City of Sandy

Planning Commission Meeting

**Meeting Date: Monday, August 24,
2020**

- 8.1. 19-050 CPA ZC SUB SAP TREE Bull Run Terrace 88 - 614
[19-050 CPA ZC SUB SAP TREE Bull Run Terrace - Pdf](#)
[Letter from Tracy Brown \(received August 20, 2020\)](#)
[Fair Housing Council of Oregon \(August 24, 2020\)](#)
[ODOT comments \(August 24, 2020\)](#)
[Public Comments \(August 14 - August 24 through 3 PM\)](#)

SHEET **C5**
 OF **10**

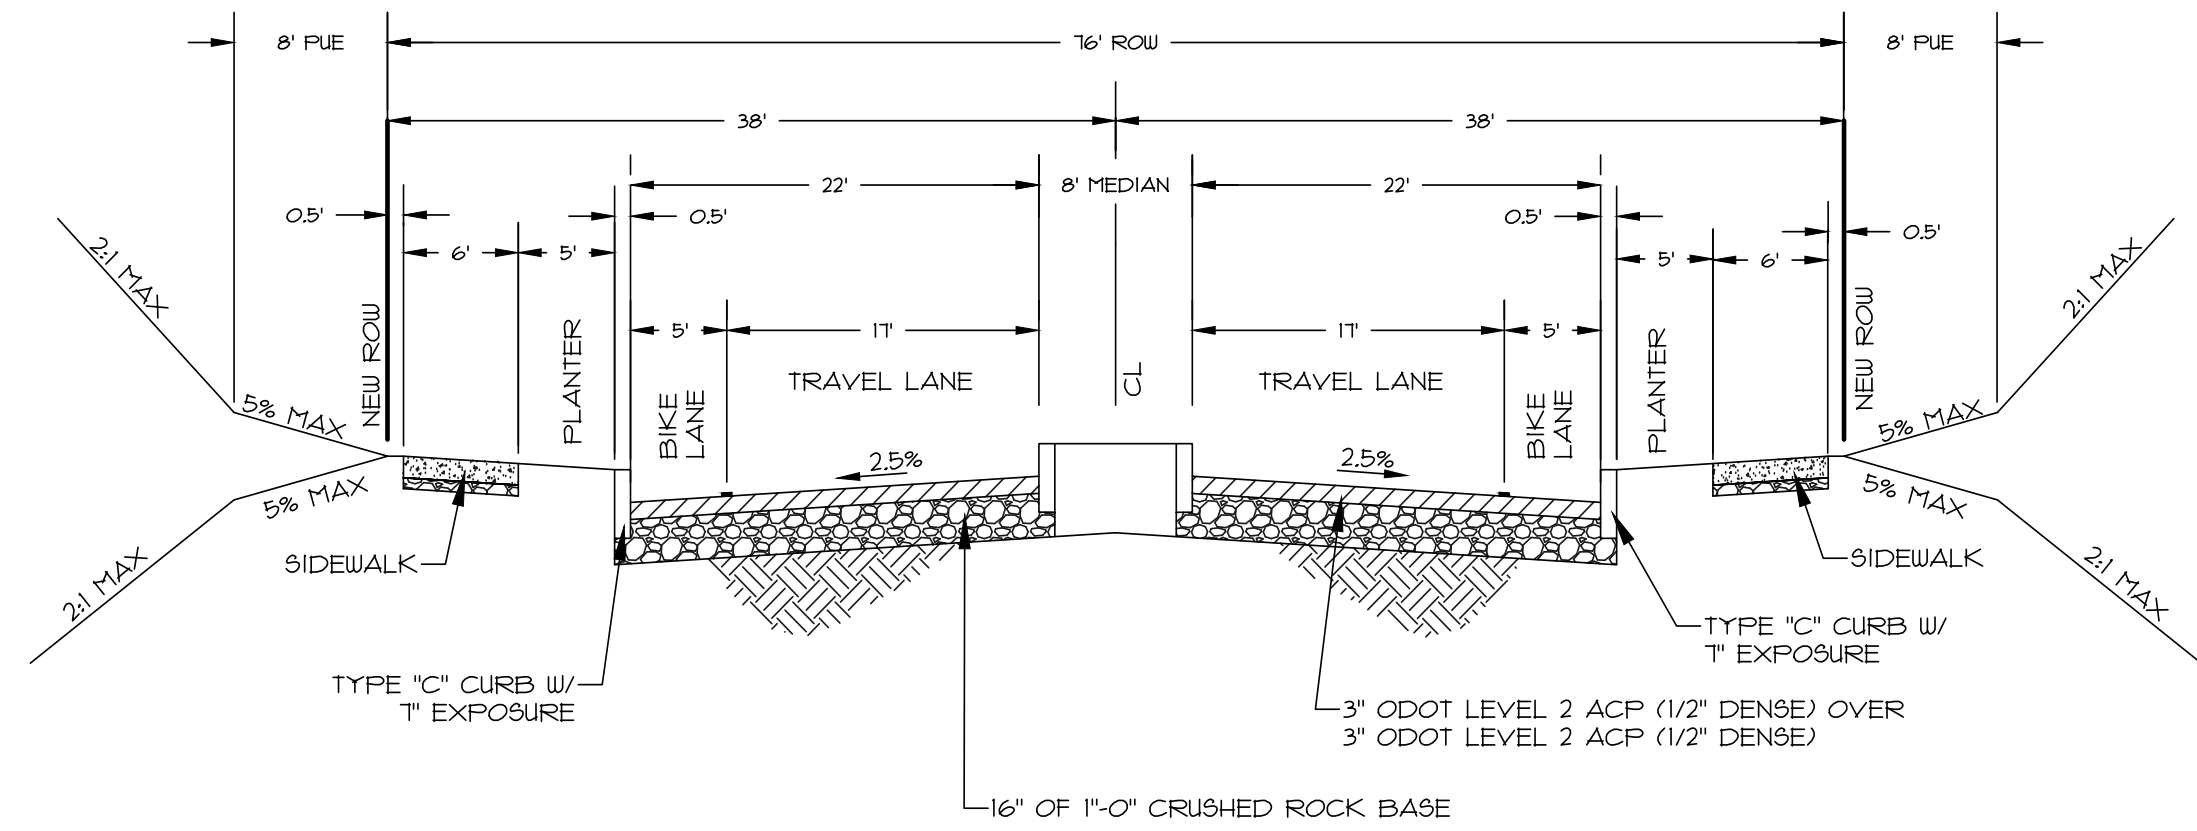
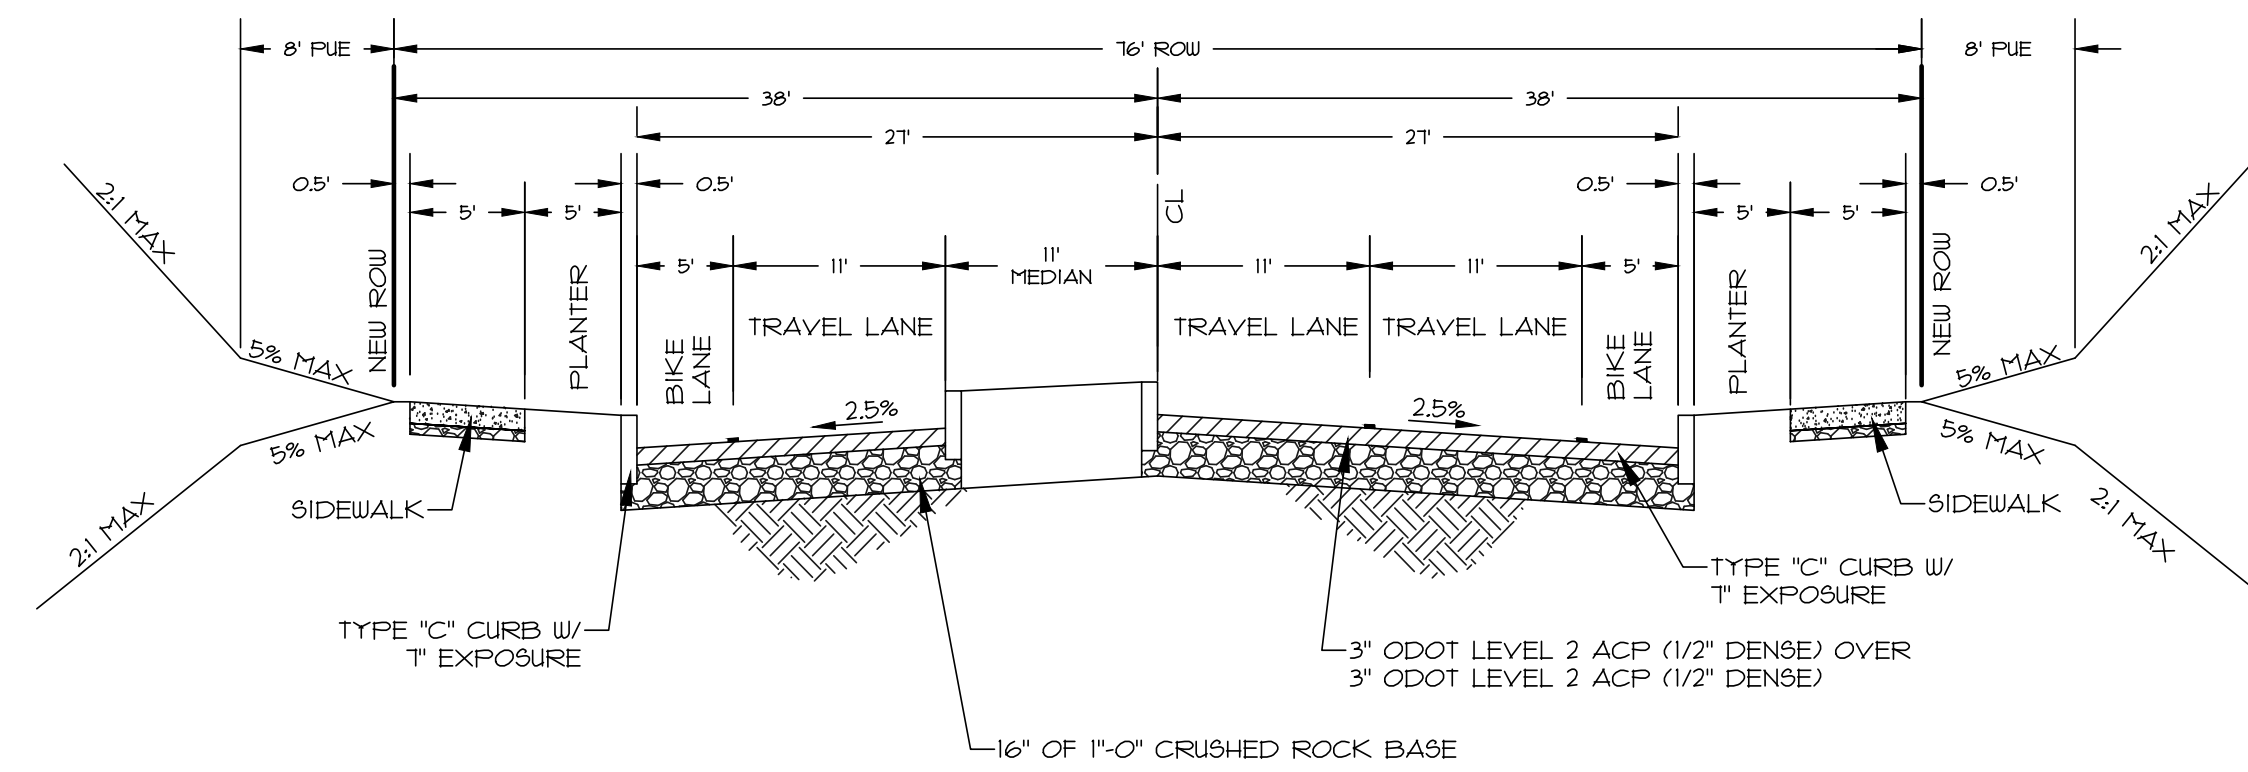
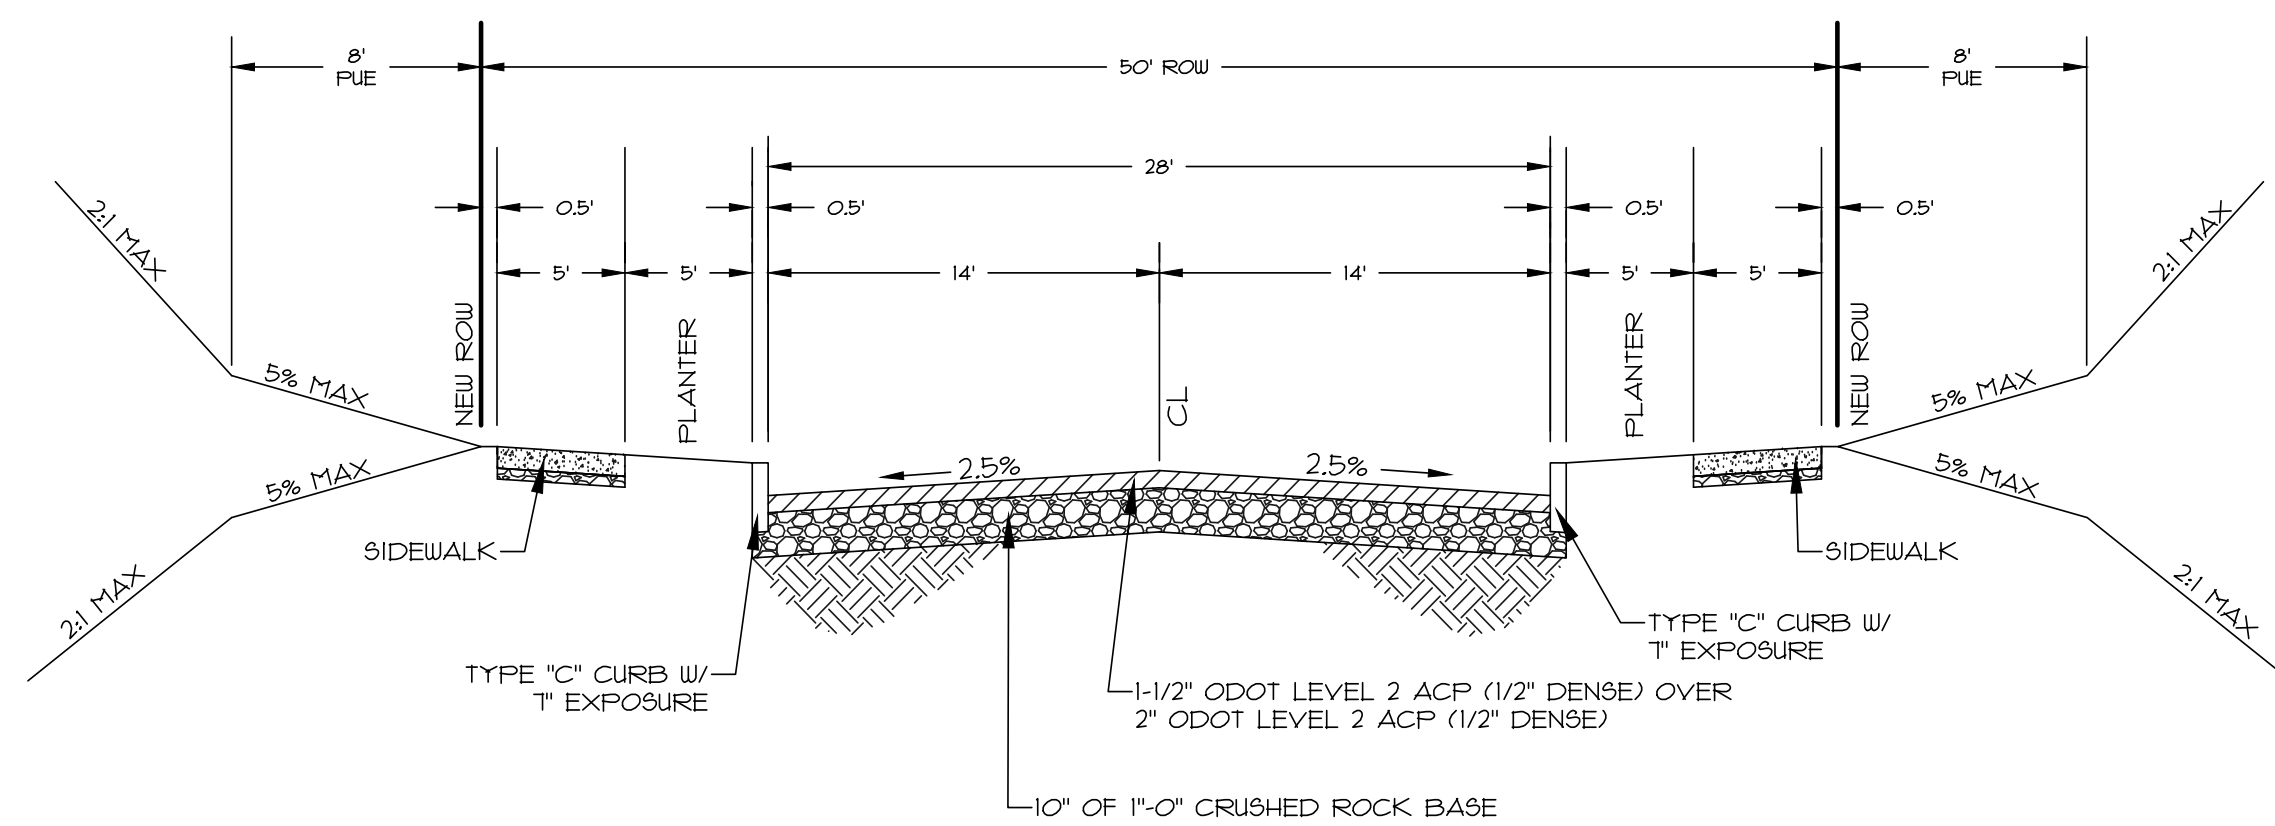
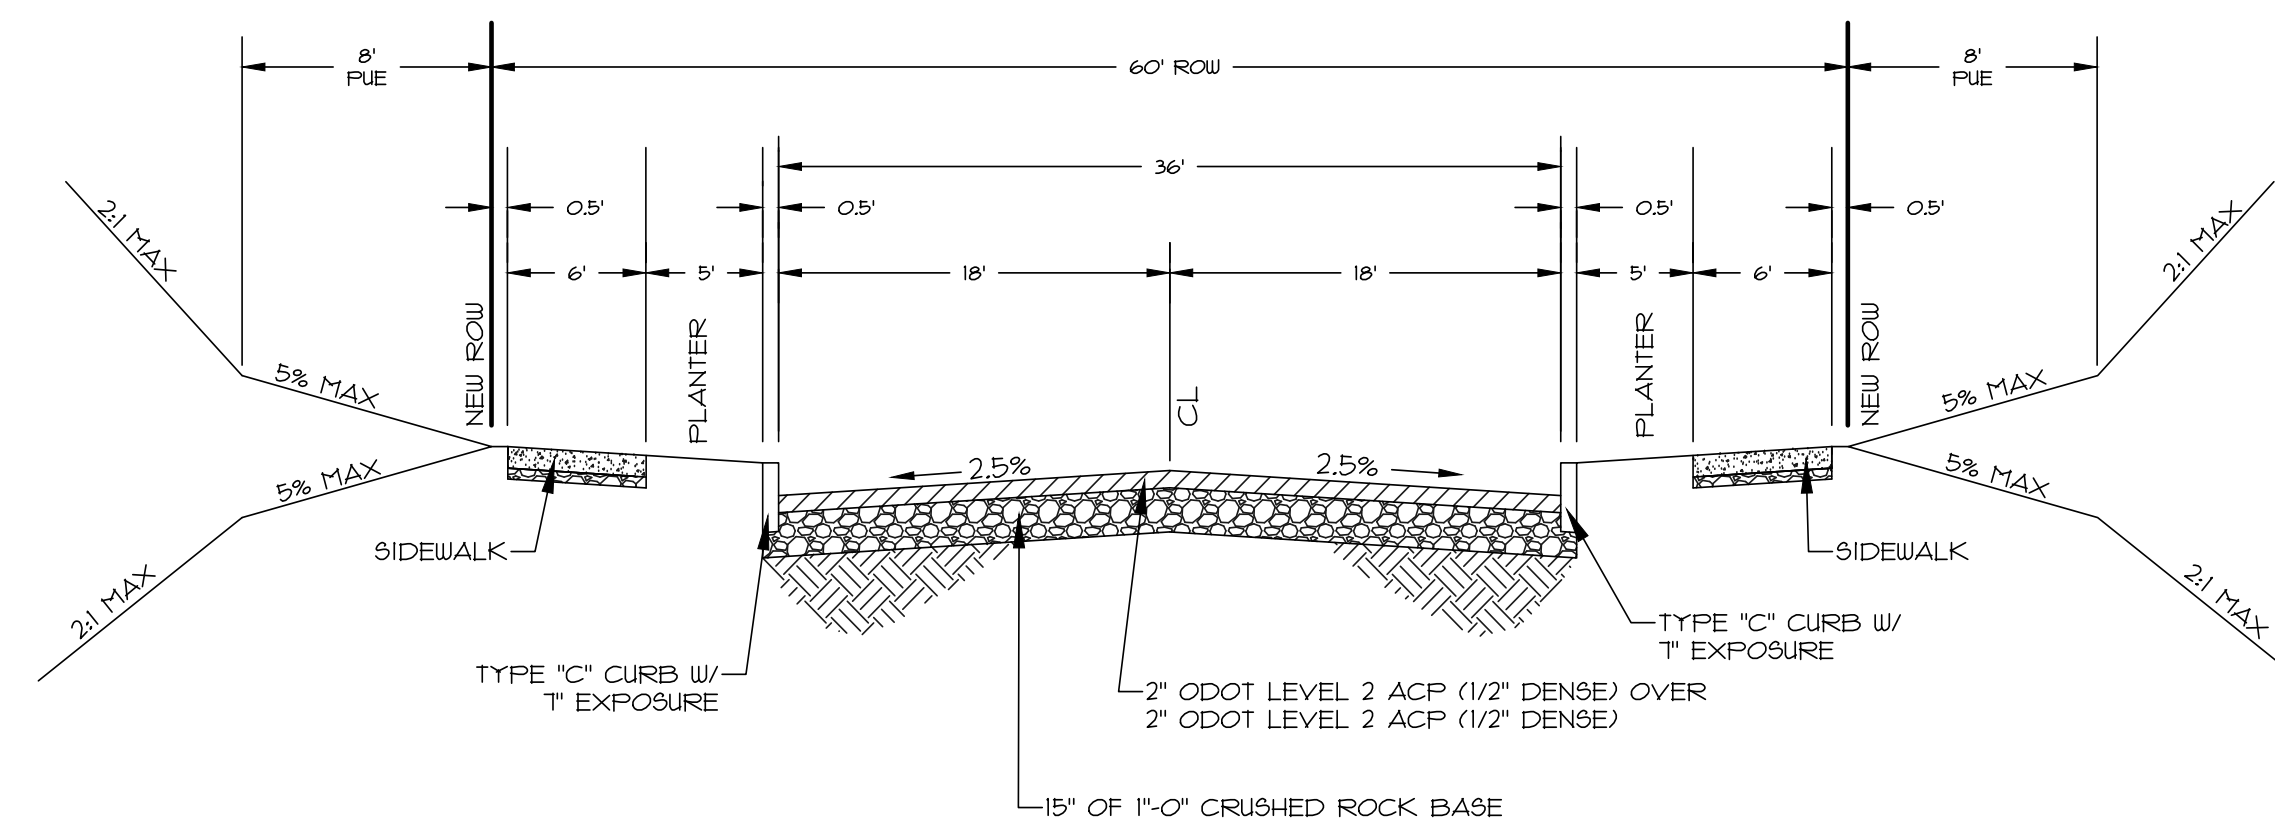
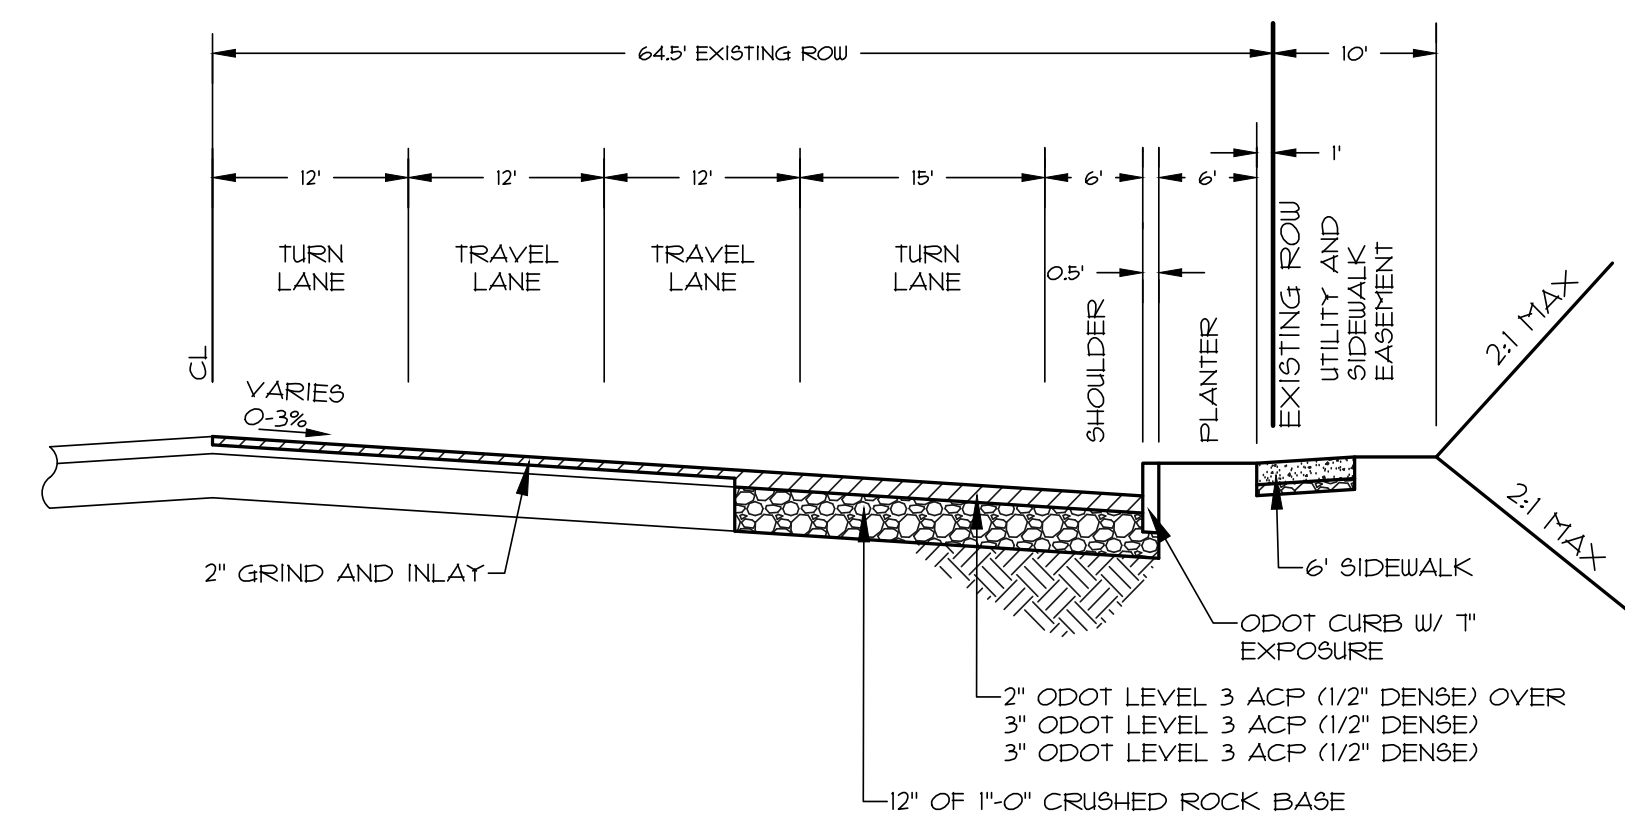
74. Section 17.84.60 outlines the requirements of public facility extensions. The applicant submitted a utility plan (Exhibit C, Sheet 5) which shows the location of proposed public water, sanitary sewer, and stormwater drainage facilities. Broadband fiber service will be detailed with construction plans. A private sanitary sewer connection is proposed to serve Lot 7. All other utilities will be public.

- f) **Detail the alignment of the intersection of Street B and Dubarko Road to provide the minimum 100 feet of tangent section.**
 - g) **Detail a 40 foot by 40 foot right-of-way dedication or permanent traffic signal easement at the northeast corner of Lot 7 to accommodate a future traffic signal.**
